PL202100191

SITE DEVELOPMENT PLANS FOR CLOVER SHOPPING CENTER REDEVELOPMENT

**CLOVER SHOPPING
CENTER REDEVELOPMENT**

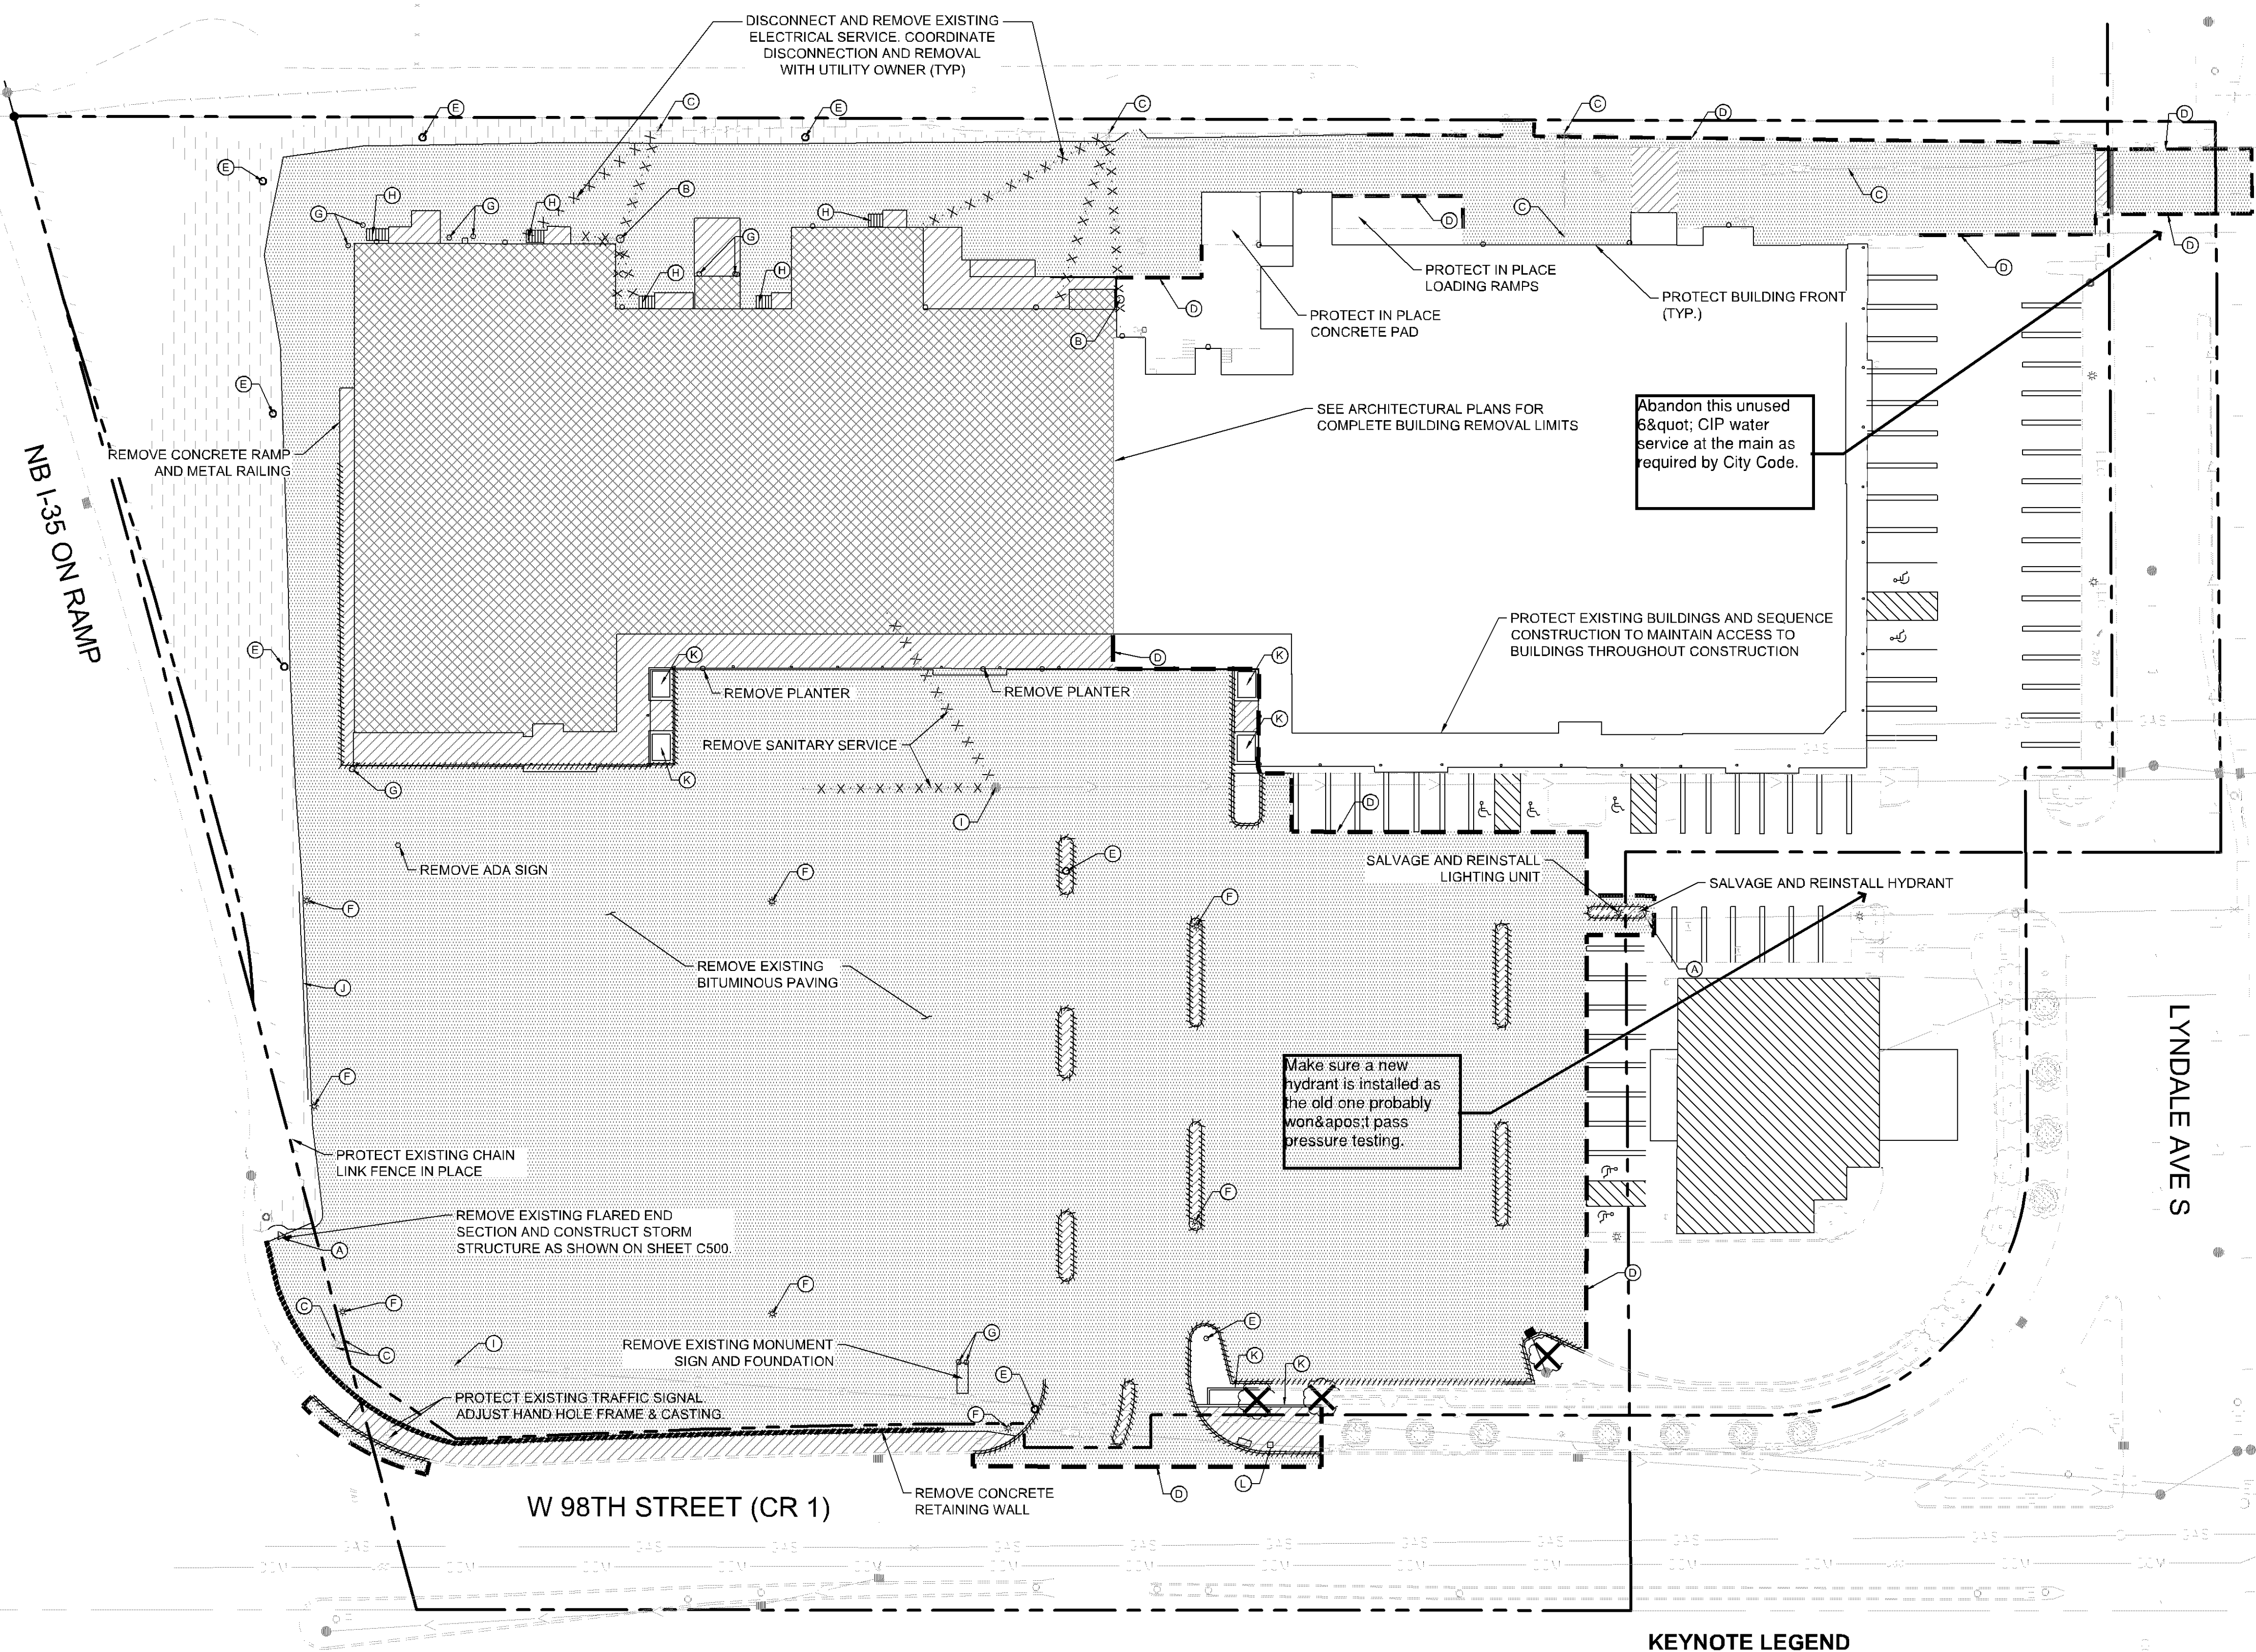
Provide adequate turning radius for all emergency vehicle access lanes.

Hydrant coverage shall be provided within 50' of the FDC and within 150' of all portions of the structure.

Fire alarm and annunciator panels and Knox box locations to be determined by the Fire Prevention Division.

Emergency responder radio coverage meeting the requirements of appendix L in the 2015 MSFC shall be provided throughout the property and within the structures.

Building/property shall be adequately signed for emergency response.

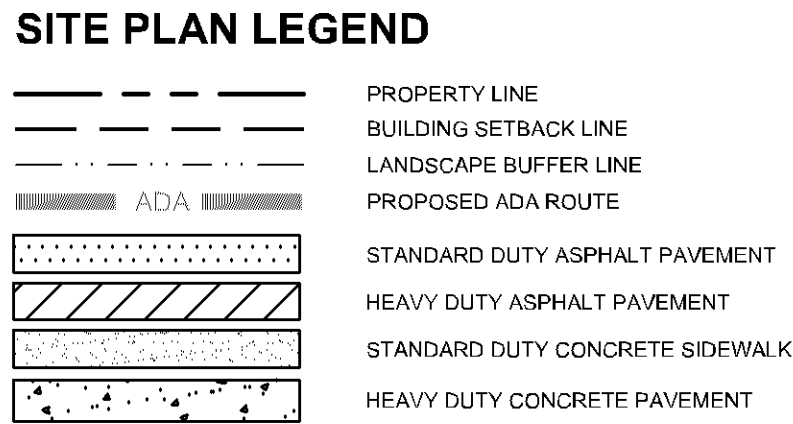
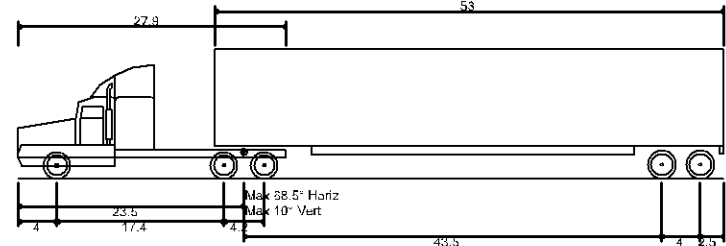
Extend curb and gutter along entire north drive lane. Maximize the landscape yard to provide buffer between Clover Center and the Freeway Ford.

Relocate sign in northeast corner of the site. Monument signs are not permitted in the B-4 district.

Two outbound lanes recommended in traffic study. WB 62 would not be able to make turn if vehicles occupied the 2 outbound lanes

LANDSCAPE PLAN

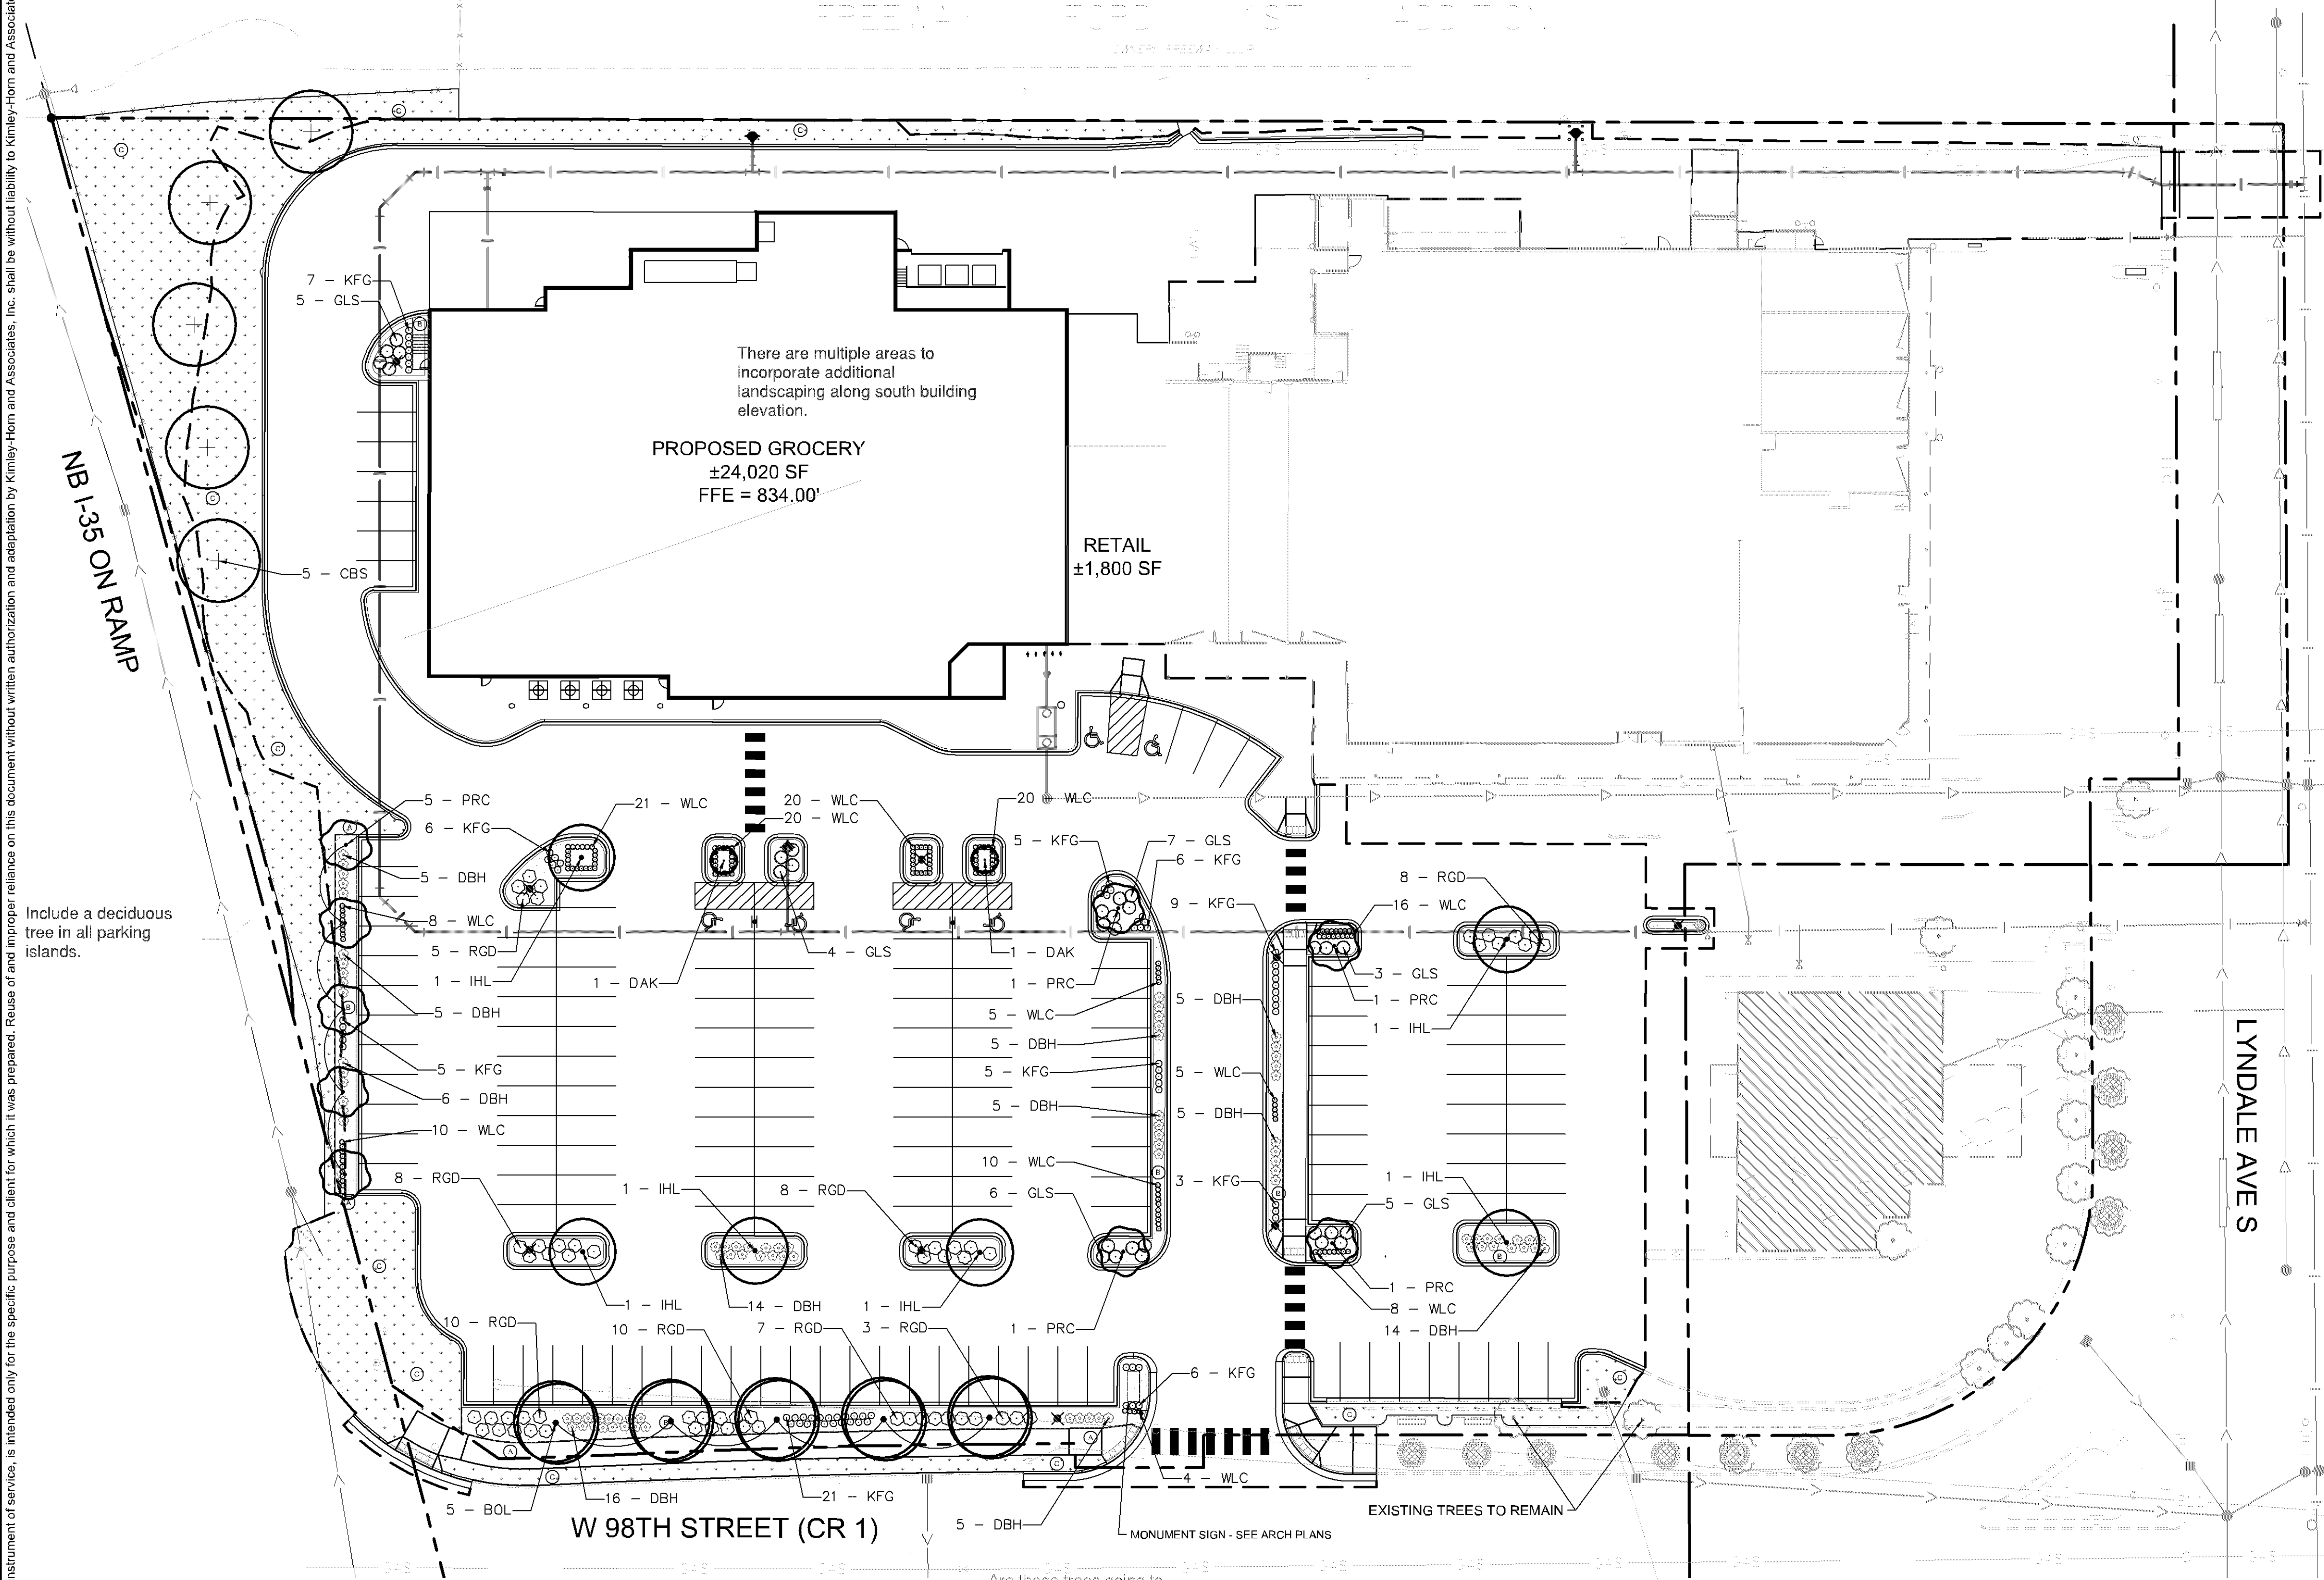
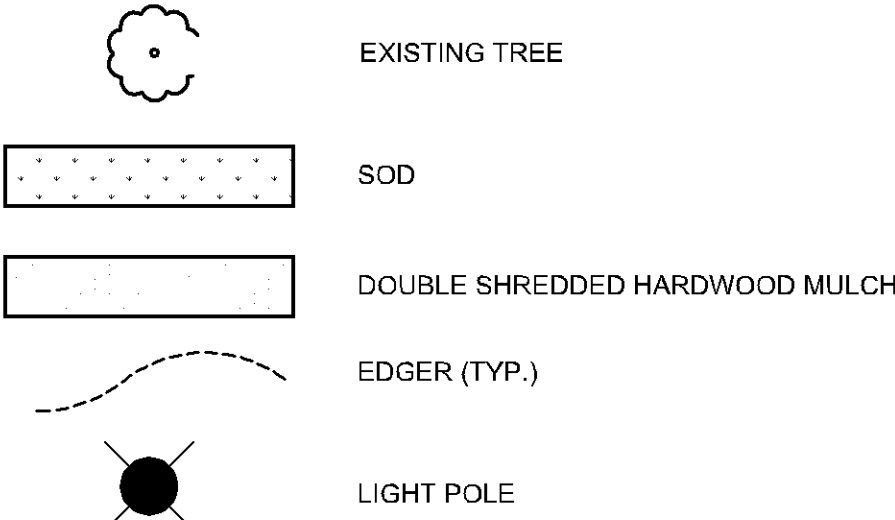
Revise plan to include at least 44 trees. Landscaping, including at least a few trees, should be incorporated in front of the grocery.
